Intel® High Definition Audio Specification Document Change Notification

Change Identification: **DCN No: HDA001-A**
Document Revision: Intel® High Definition Audio 1.0

Title: Clarification to Interrupt Status

Section 3.5 of the Intel® High Definition specification version 1.0 defines:

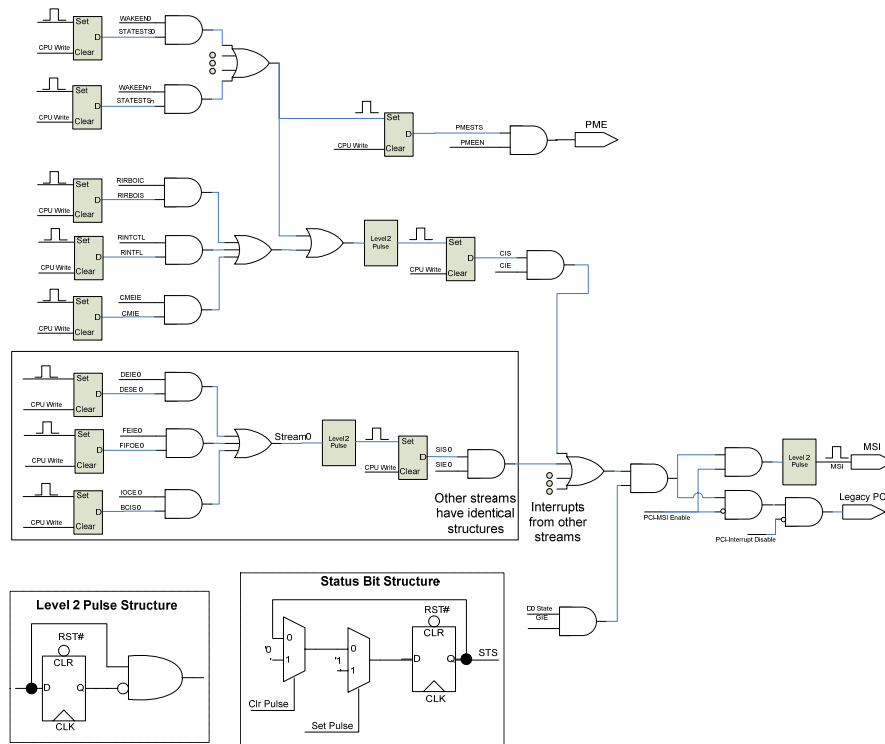
The Intel® High Definition Audio specification version 1.0 specifies that Interrupt Status bits CIS and SIS are sticky and written to 1 to clear, but with the known implementations CIS and SIS are an OR of the interrupt condition and can not be cleared by writing a 1. As current implementations differ from the specification the specification is updated to reflect the real world implementations.

Section 3.5

Error! Reference source not found. is a representation of the interrupt tree to show the logical relationship of various signals. It should not be taken as a literal implementation.
